Re: **Lake Chelan Hydroelectric Project No. 637**  
**License Article 401 and Water Quality Certification Condition V.B**  
**Chelan River Water Temperature Modeling Quality Assurance Project Plan**

Quality Assurance Project Plan for the Chelan River Temperature Model  
Response to Ecology (WDOE) Comments Dated February 21, 2014 Regarding Draft Quality  
Assurance Project Plan Chelan River Temperature Model Issued January 15, 2014

# Response to Ecology (WDOE) Comments Dated February 21, 2014

## Regarding Draft Quality Assurance Project Plan

**Figure 2. Lake Chelan Hydroelectric Project general views.**

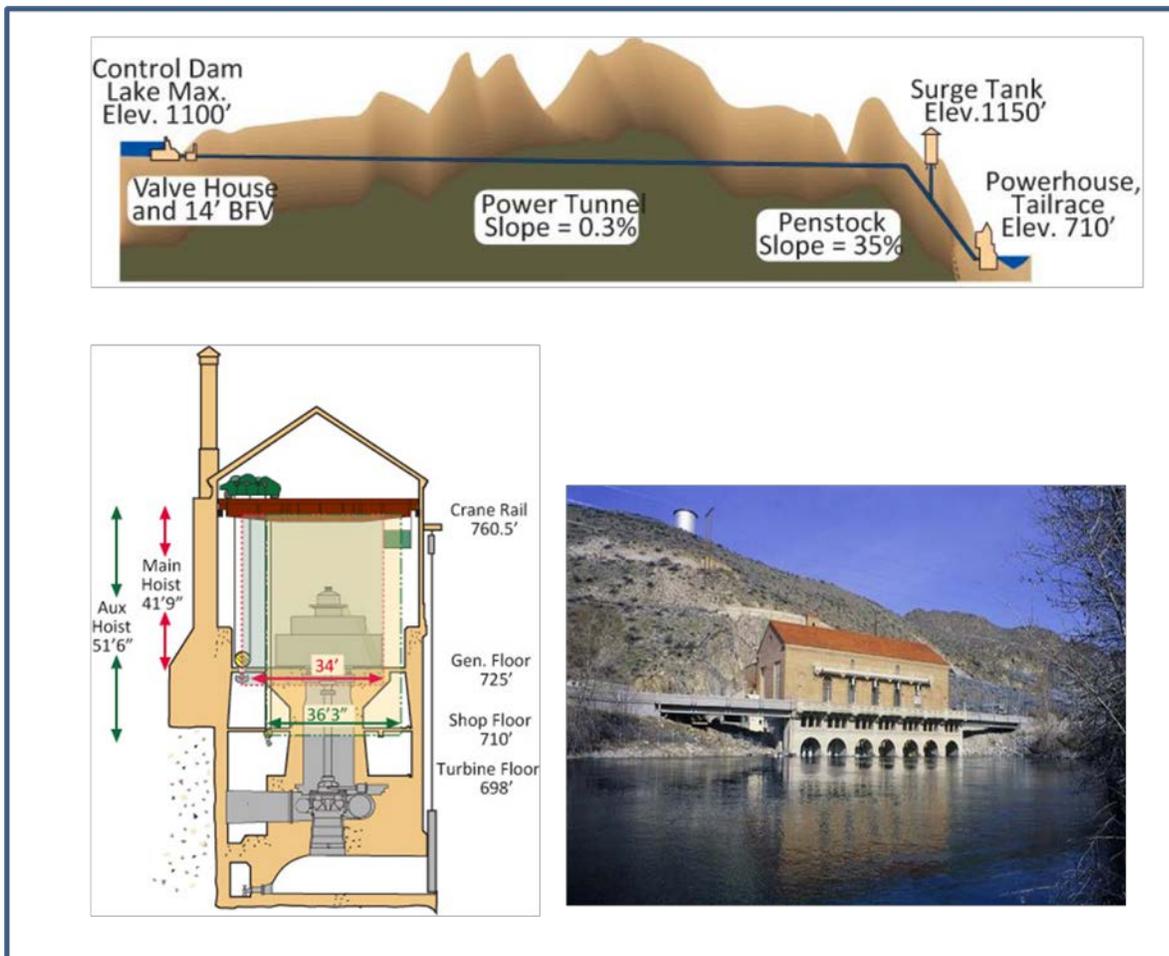
**COMMENT 3:** A graphic of the dam, penstocks, and powerhouse would be helpful.

**RESPONSE 3:** Included as Figure 2.

Figure 6. Low Level Outlet intake structure and temperature probe locations.

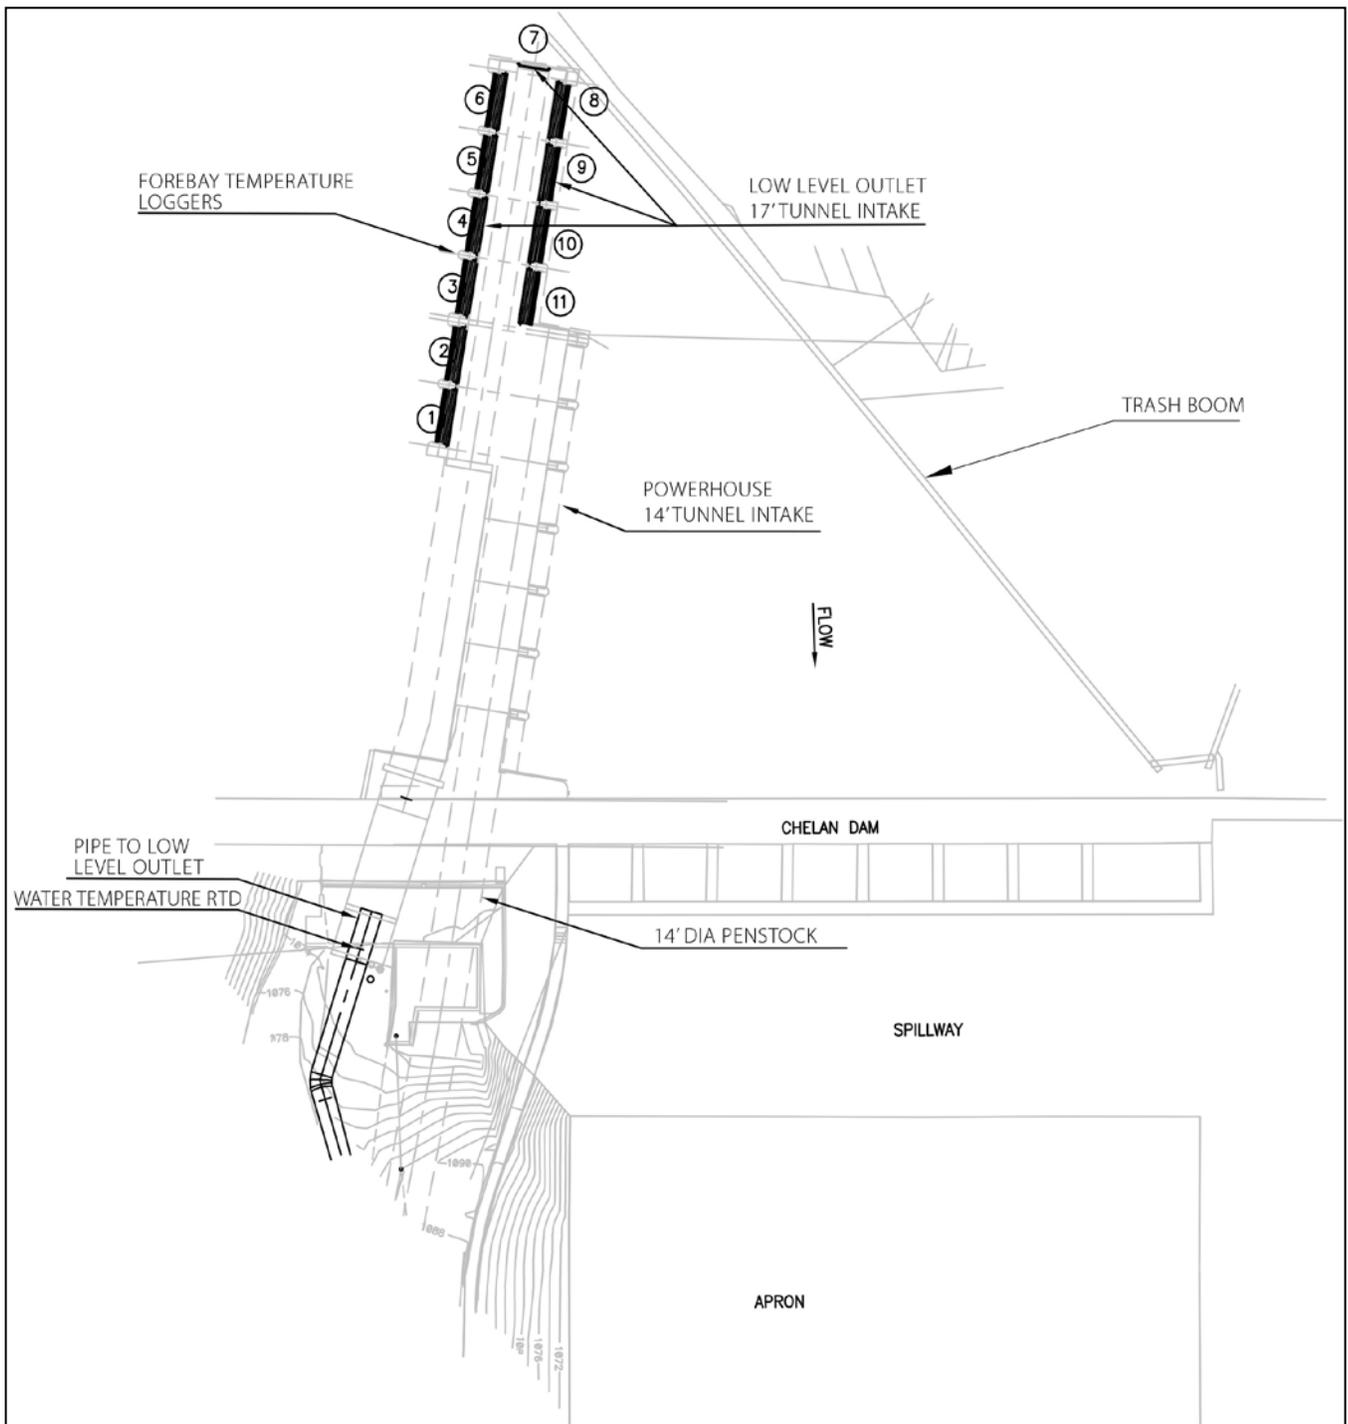
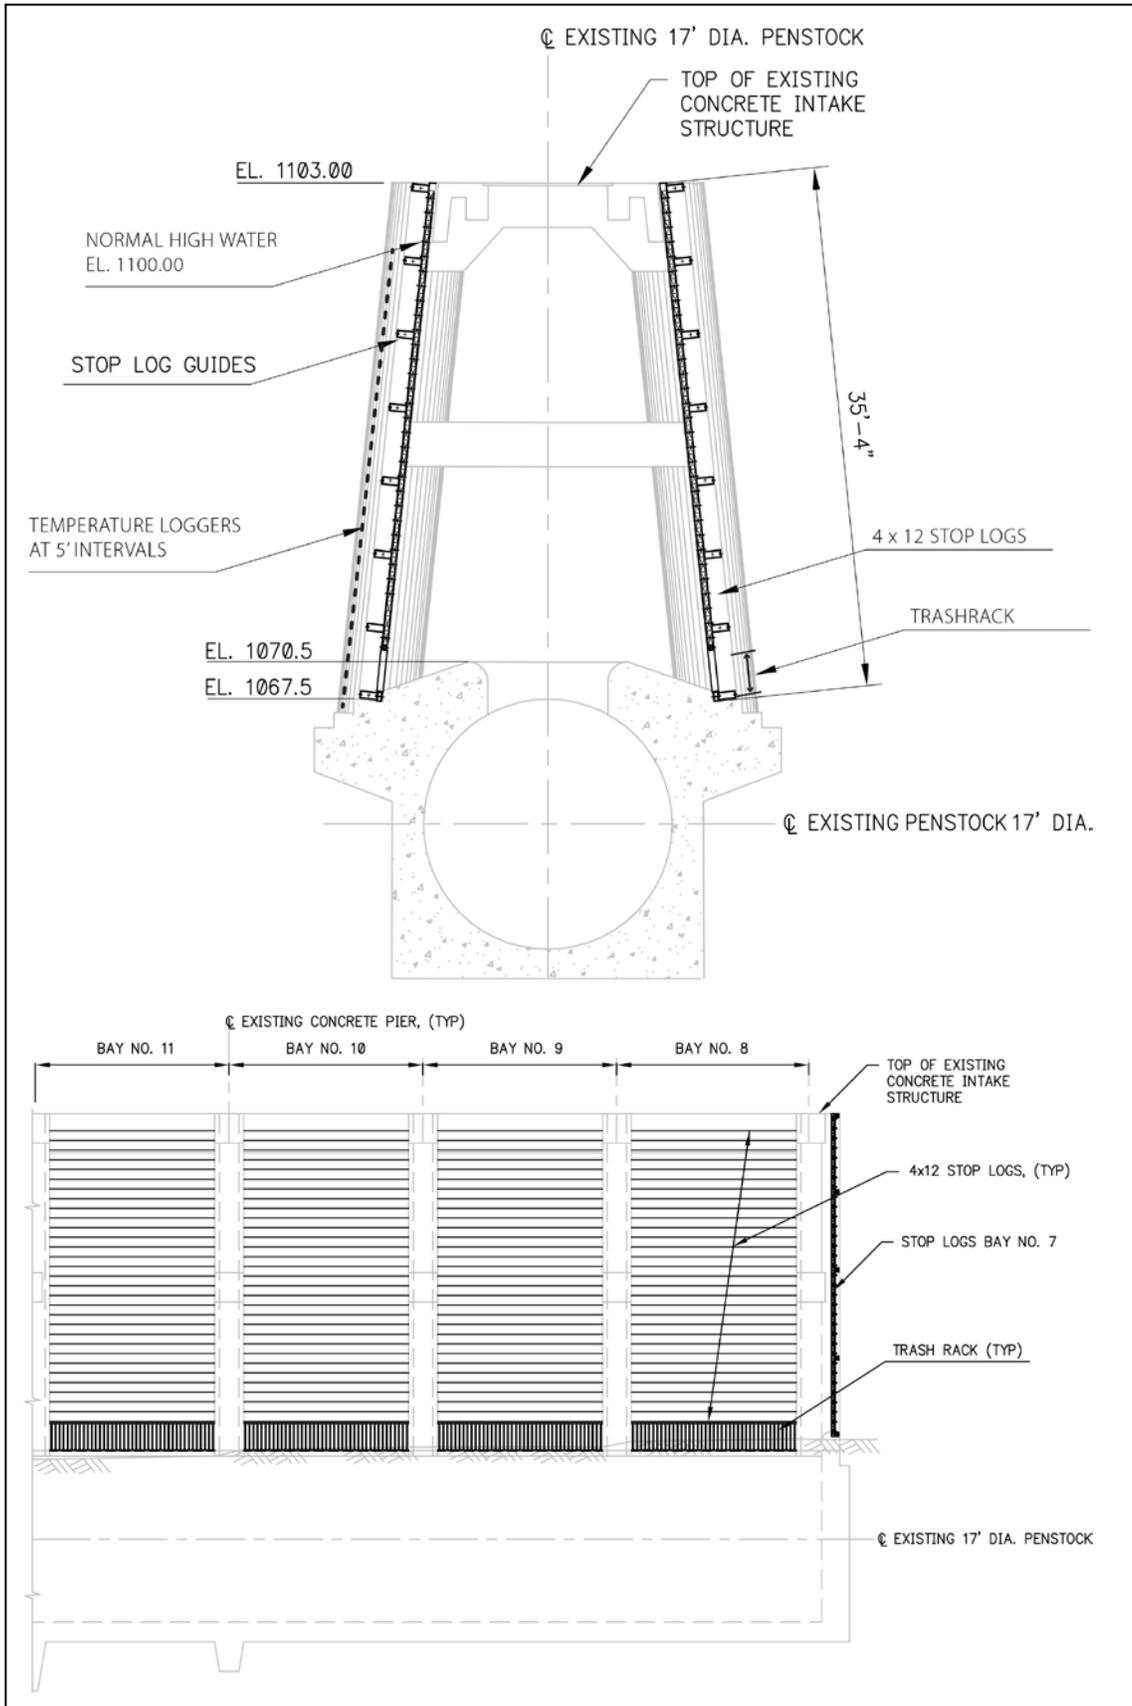
**COMMENT 10:** Provide a zoomed-in map of the forebay with location of thermistor strings, low level outlet thermistor, outlet inlet, etc.

**RESPONSE 10:** Figures 6 and 7 added.

**Figure 9. Vertical temperature difference in Lake Chelan forebay**

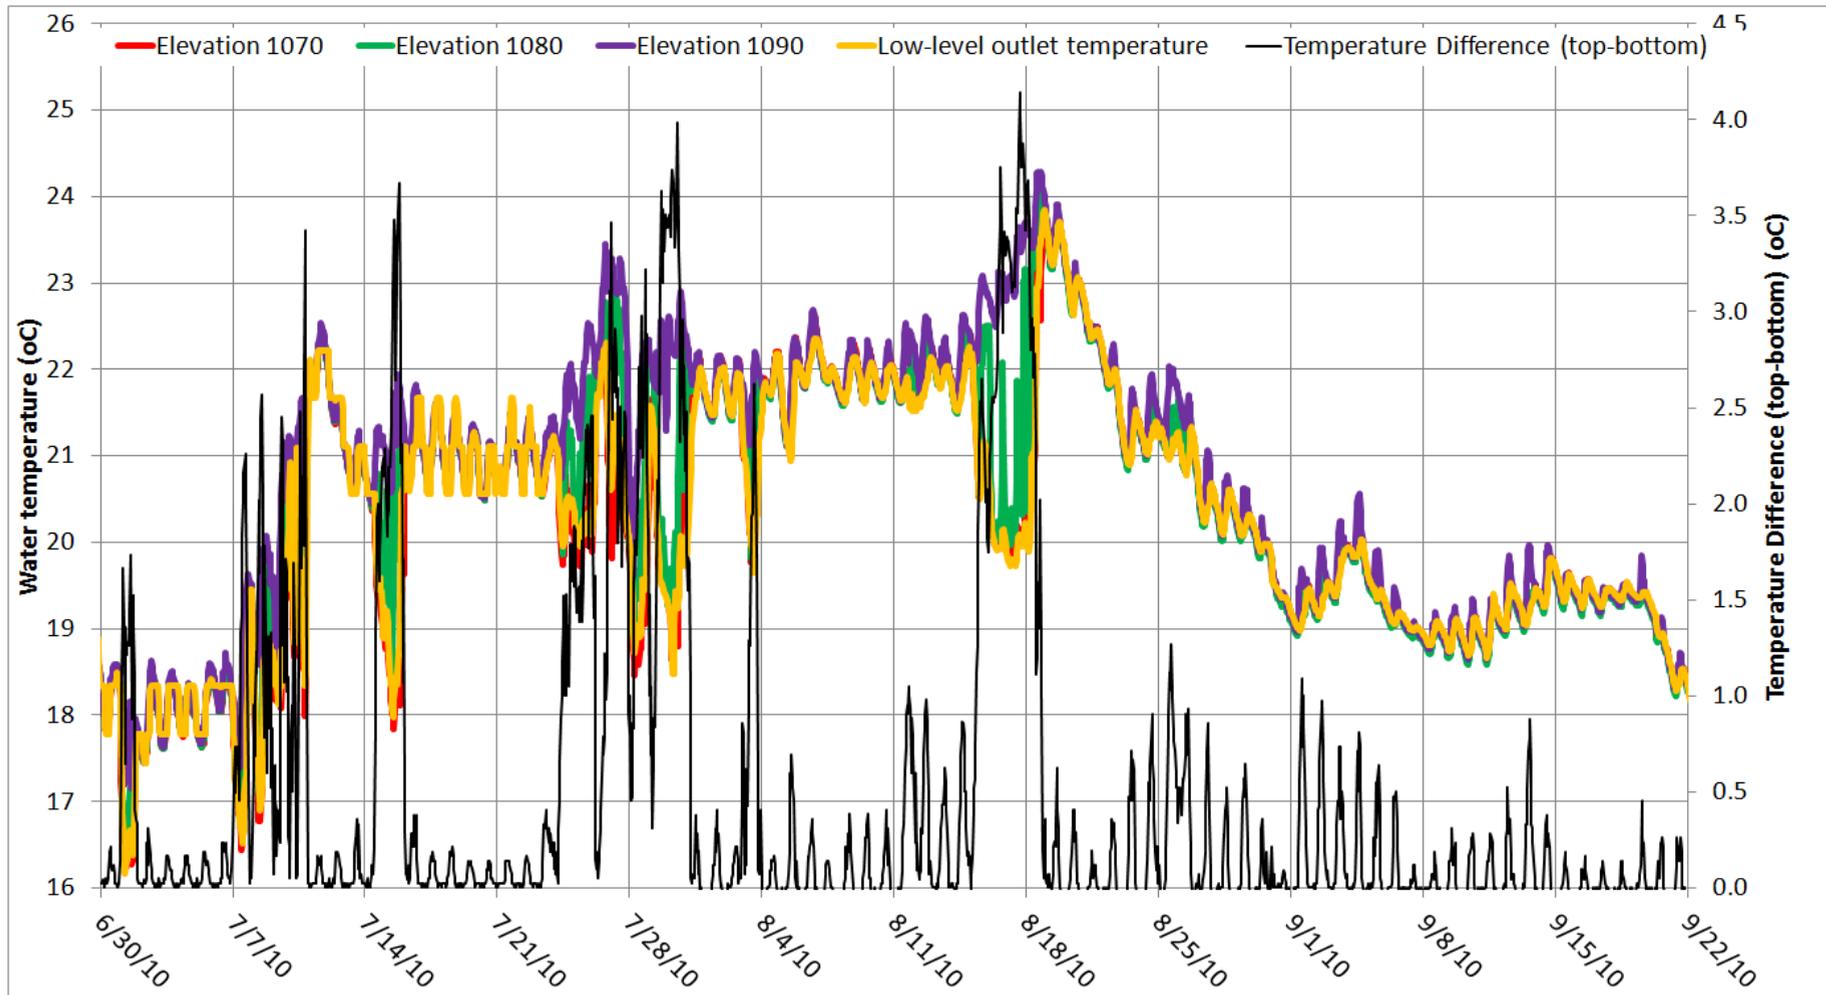
**COMMENT 25:** Explain exactly how “temperature difference” is calculated, including which monitoring location(s) are used. (Figure 9, too)

**RESPONSE 25:** Text modified to clarify.
